REVIEW OF APPLICATION FOR RE-CERTIFICATION BY THE LOW IMPACT HYDROPOWER INSTITUTE OF THE RED BRIDGE HYDROELECTRIC FACILITY

Prepared by Patricia McIlvaine

November 13, 2018

Figure 2 – Red Bridge Project Zones of Effect

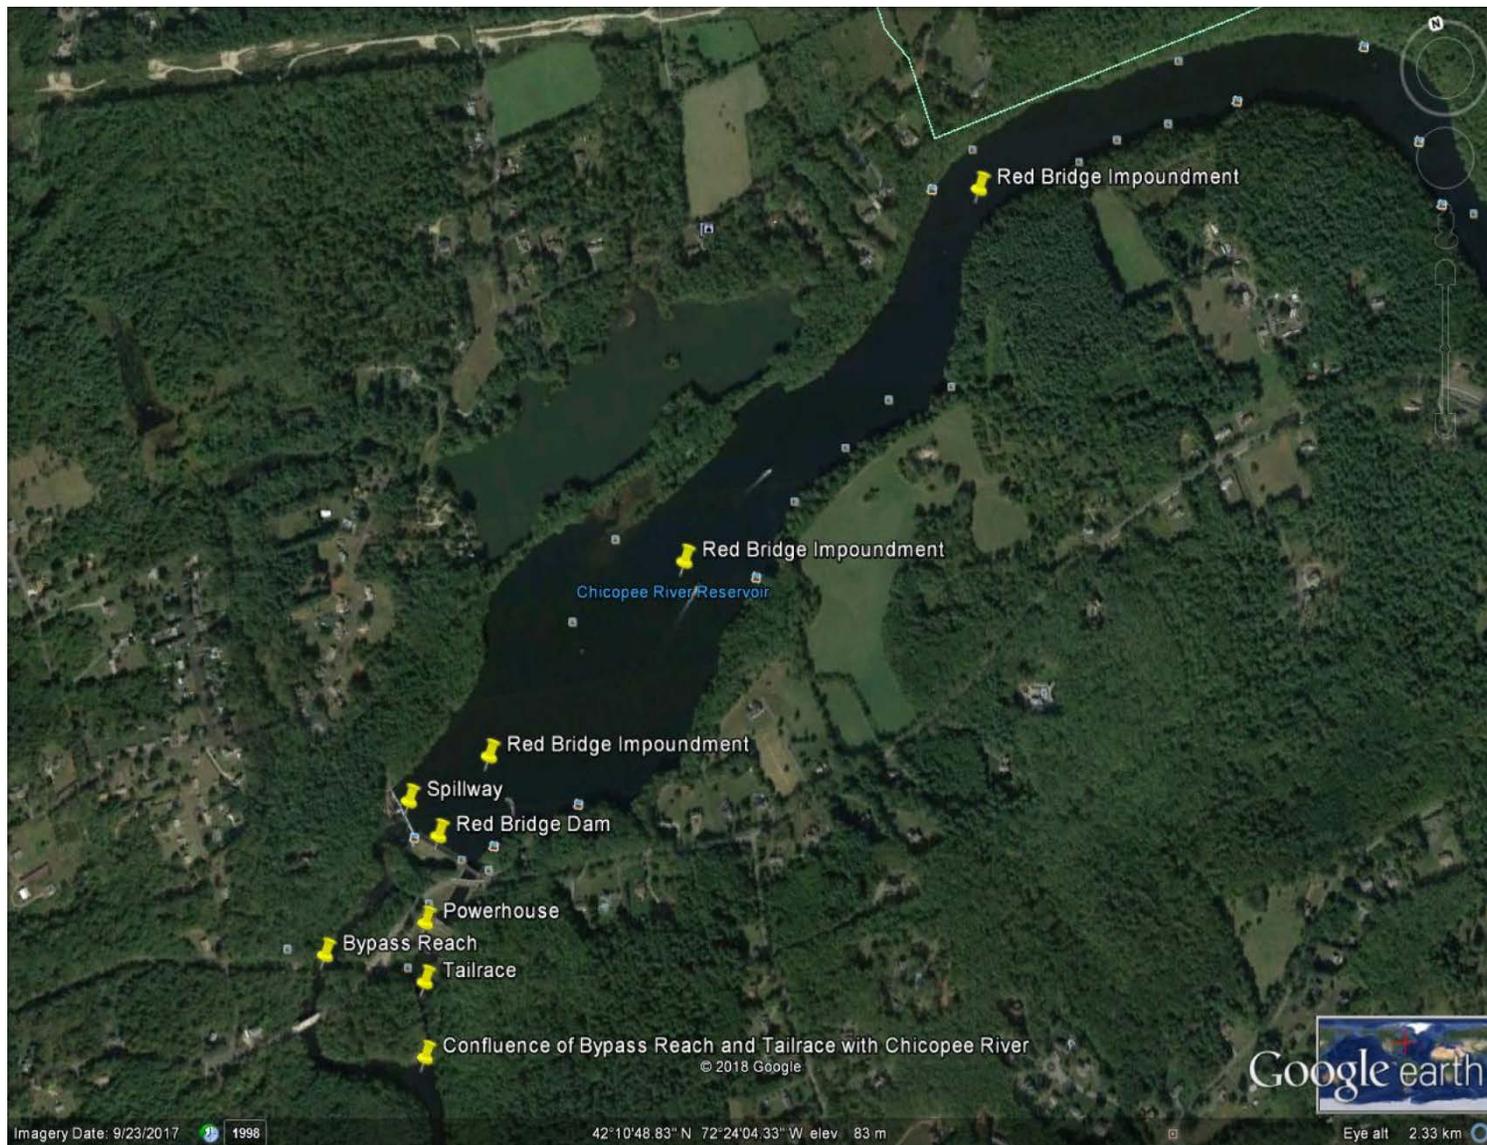
Three Zones of Effect (ZOE) were designated by the Applicant and were determined to be appropriate. These are identified on Figures 2 and 3 in Appendix A.

- ZOE #1 – Impoundment
- ZOE #2 – Bypass Reach
- ZOE #3 – Tailrace and Regulated Reach
